**City of Portland, Maine - Building or Use Permit Application**

Permit No: 02-0278	Issue Date: <b>JUN 28 2002</b>	CBL 347 C039001
-----------------------	-----------------------------------	--------------------

Location of Construction: 1476 Washington Ave	Owner Name: Hurtubise Dana P &	Owner Address: 210 Coyle St	Phone: 773-0097
Business Name: n/a	Contractor Name: n/a	Contractor Address: n/a Portland	Phone:
Lessee/Buyer's Name: n/a	Phone: n/a	Permit Type: Alterations - Dwellings	Zone: <b>R-3</b>

RE: 1476 Washington Avenue – R-3 zone – 347-C-039

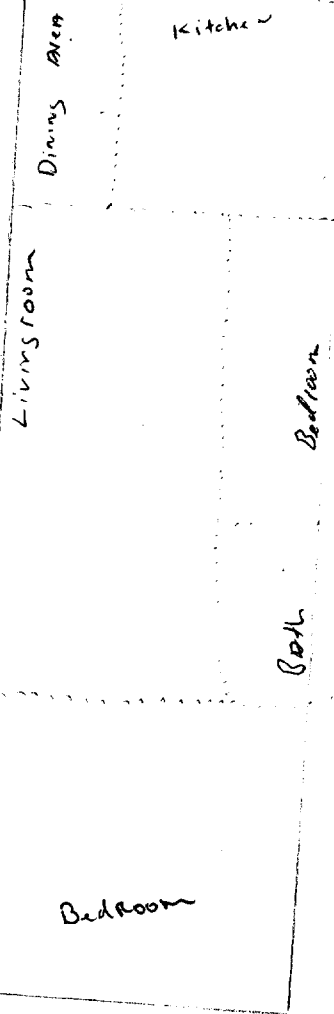
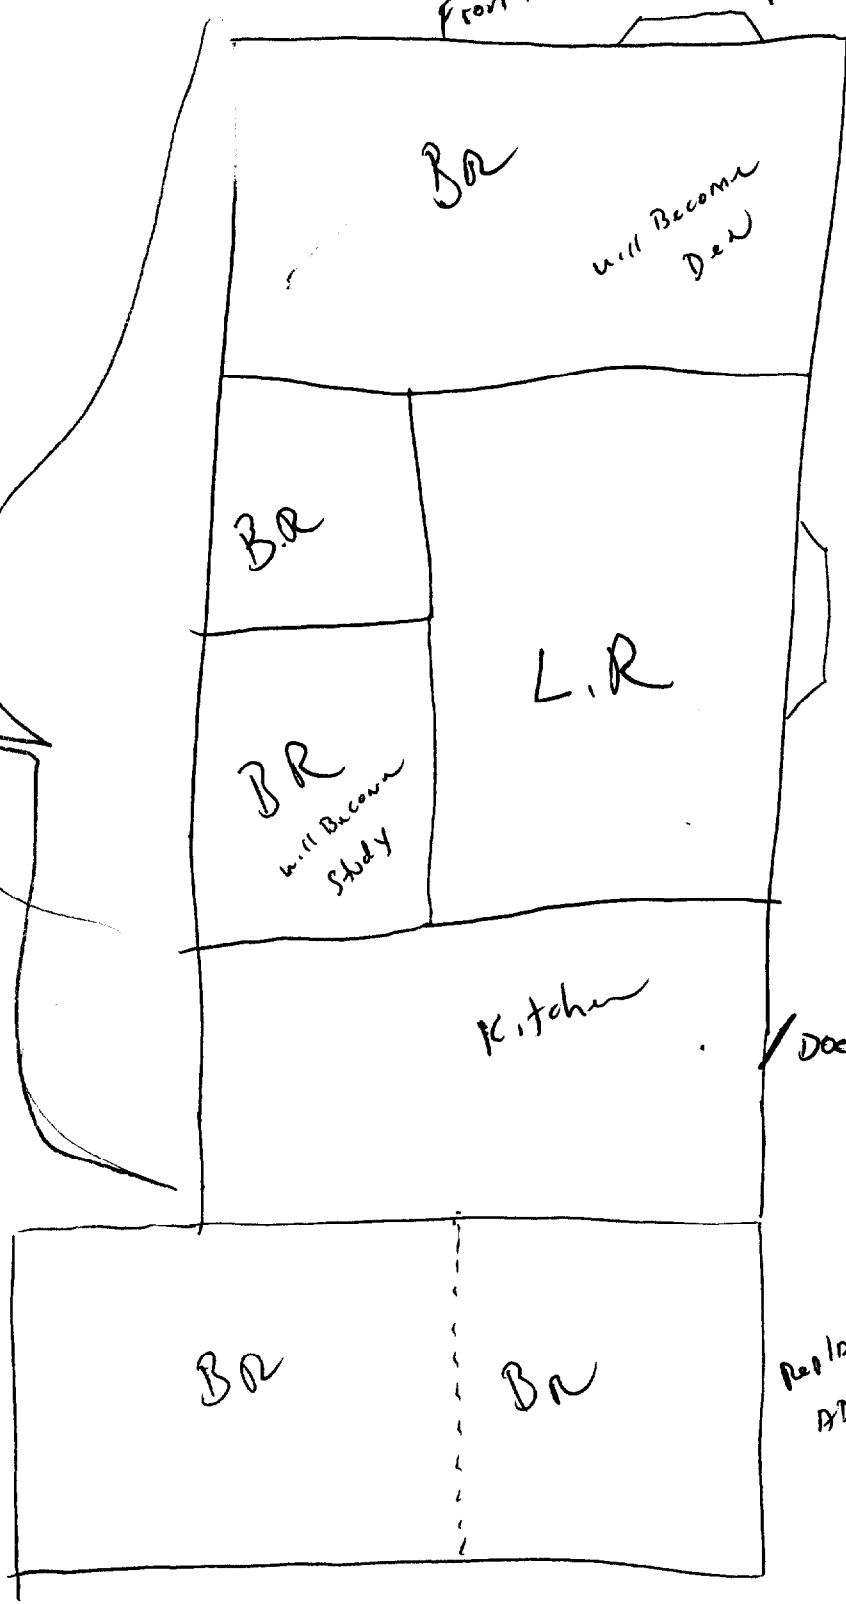
I will also need an accurate site plan. The one that was submitted can not be accurate. The rear setback given on this plan shows 150' from the rear of the building to the rear property line. The Assessor's plans show the entire lot to be 150' deep. Therefore the setback can not be the same length.

R-3 Zone  
 Rear: 25' req - 53' shown  
 Side: 14' req - 30' shown  
 Front: 25' req - 97' / 81' shown

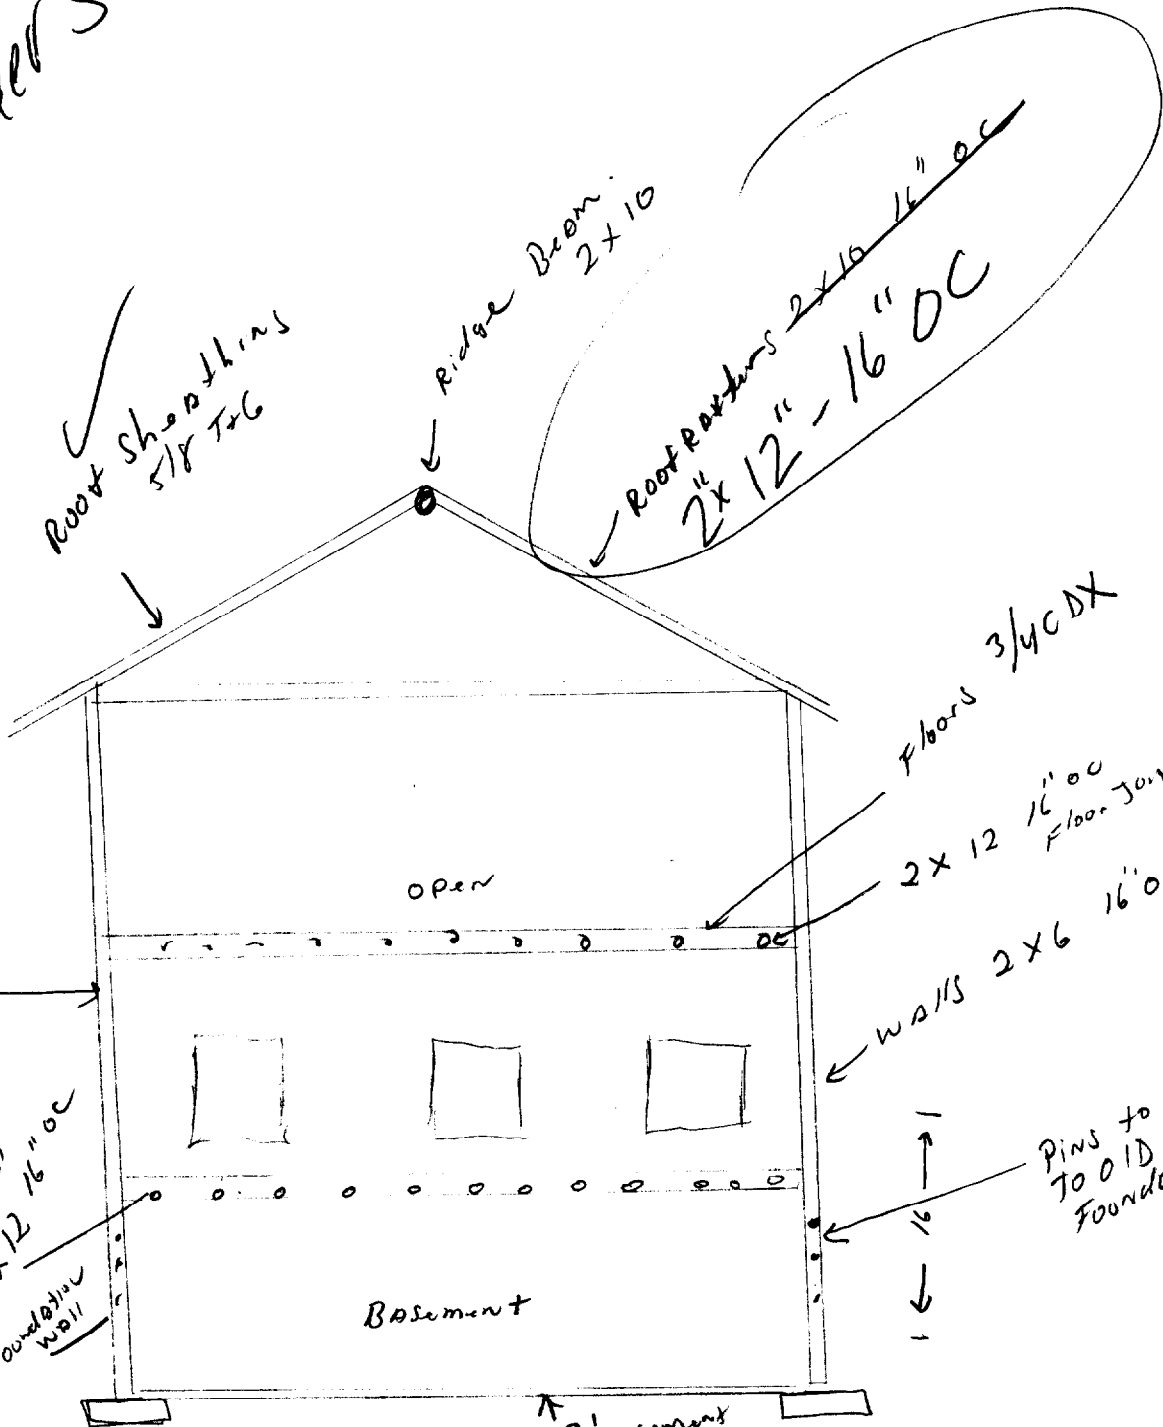
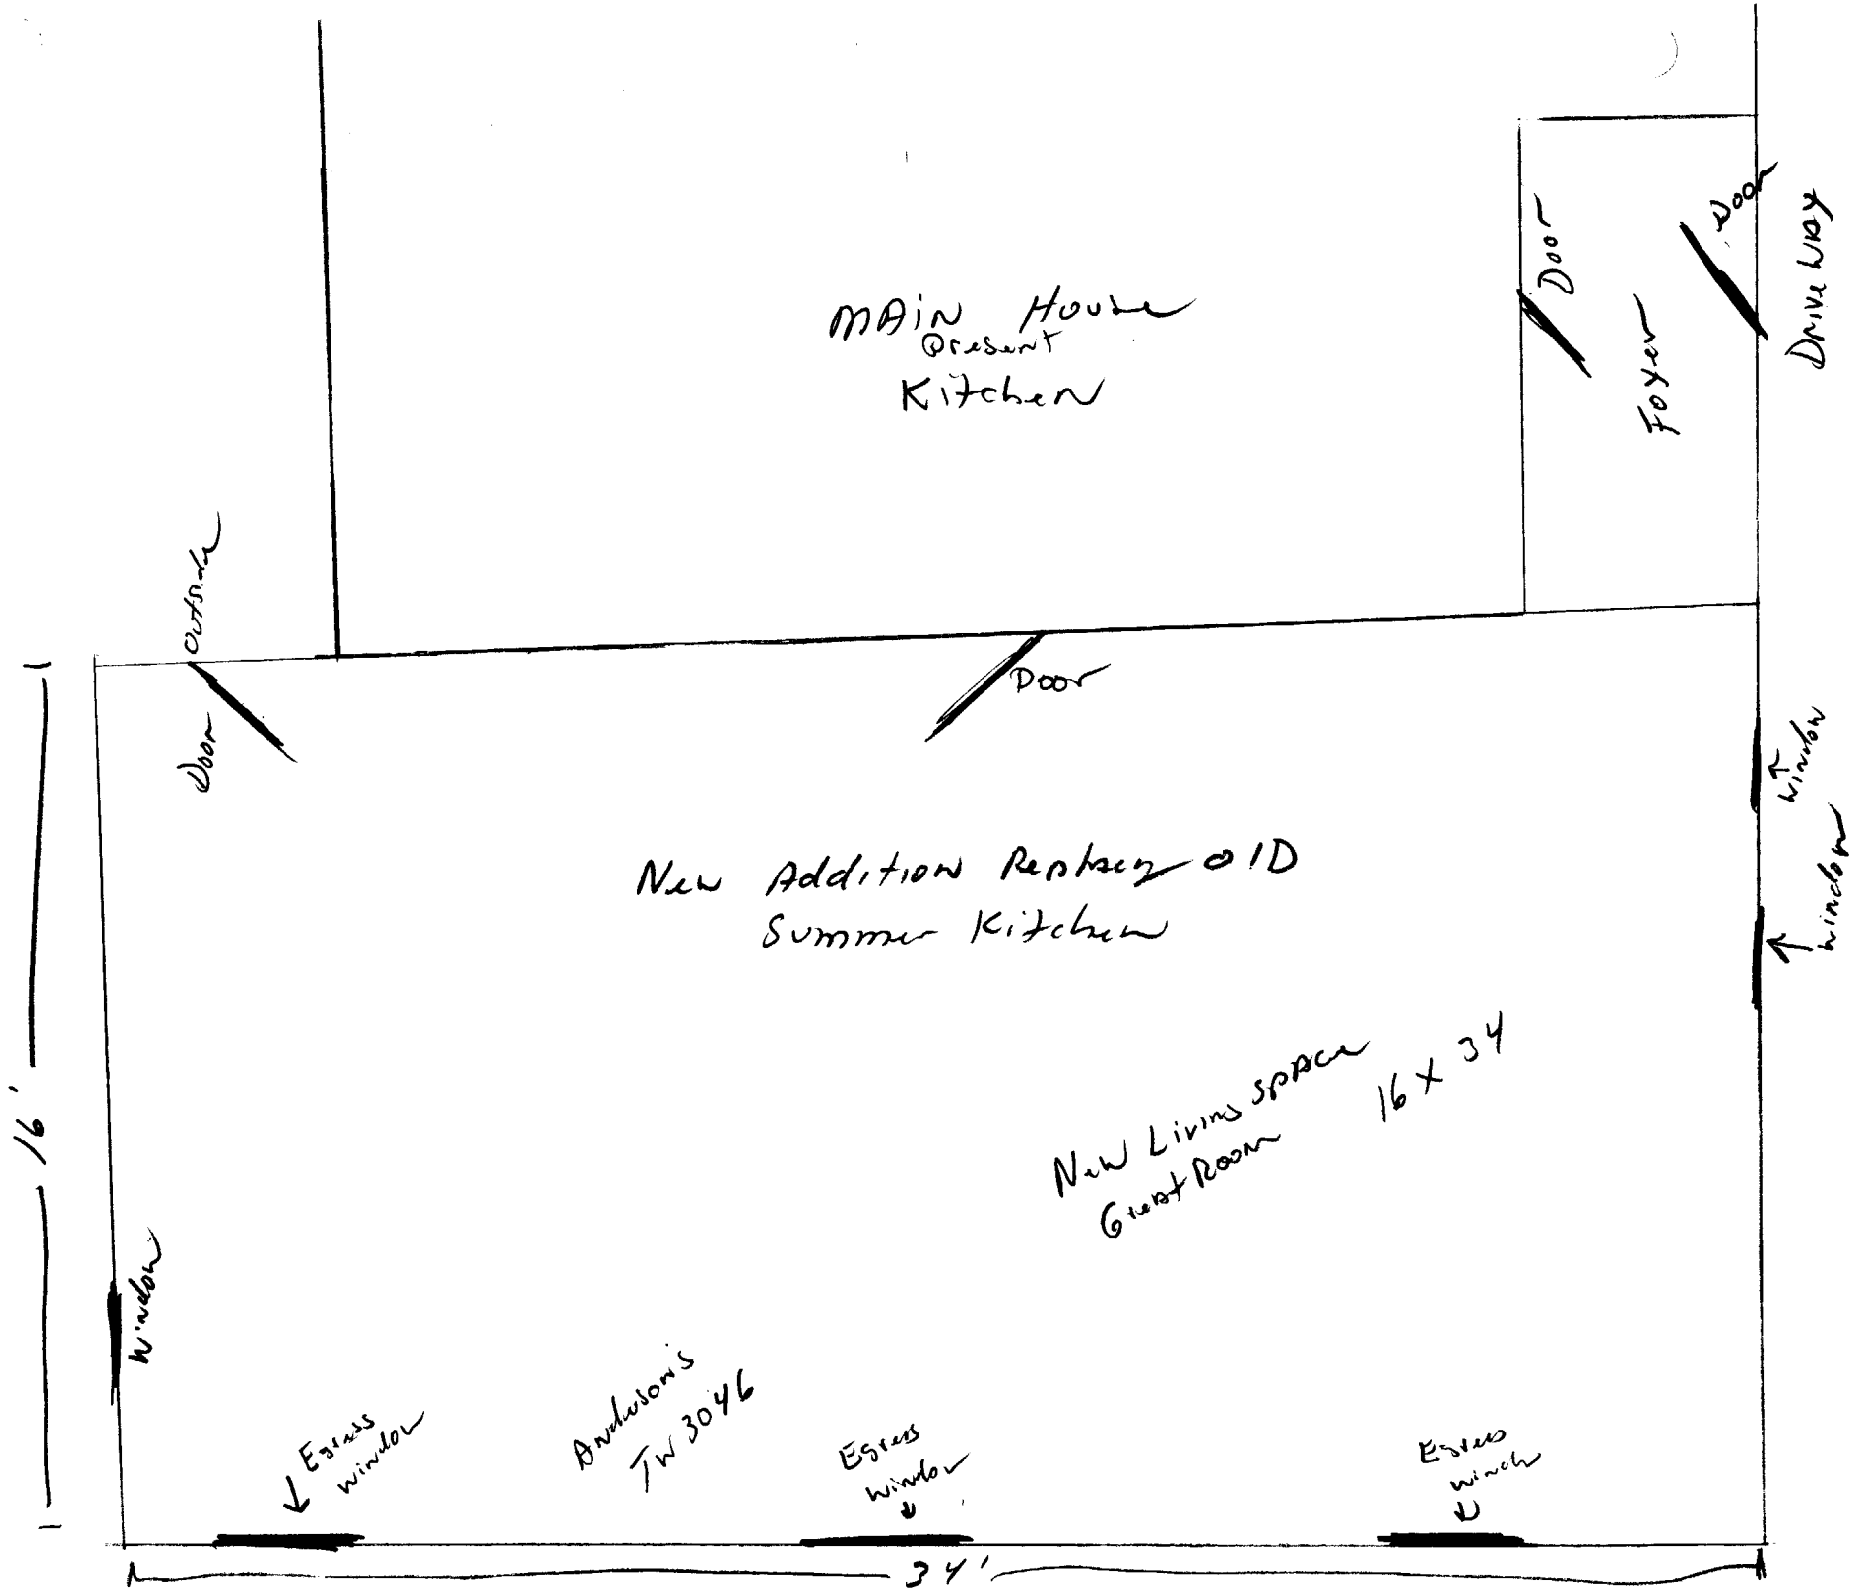
- ① 4" floor ✓ - Will be 4"
- ② Anchor bolts ✓ - 6' oc
- ③ Drain tile w/fabric -
- ④ 2x10 Rafter - 14'-6" span } Rafter will be 2x12-16" oc
- ⑤ Headers - All - 3-2x10's - no openings over 3'-0"
- ⑥ Stairs to outside ✓ - OK - brought in sketch
- ⑦ Smoke S - will update building & add in bedrooms
- ⑧ Egress Windows - will be in bedrooms
- ⑨ 1 hour between floors ✓  
OK will do. left message  
to call -  
Spoke w/his  
wife.

Roof Rafter will be 2 x 12 16' on center.

Window Hardware will be 3 2 x 10<sup>3</sup> coated steel.

Each Bedroom will have a Hardwire Smoke detector

A 1 hour burn ceiling between floors

the Basement floor will be 4" coated steel mesh
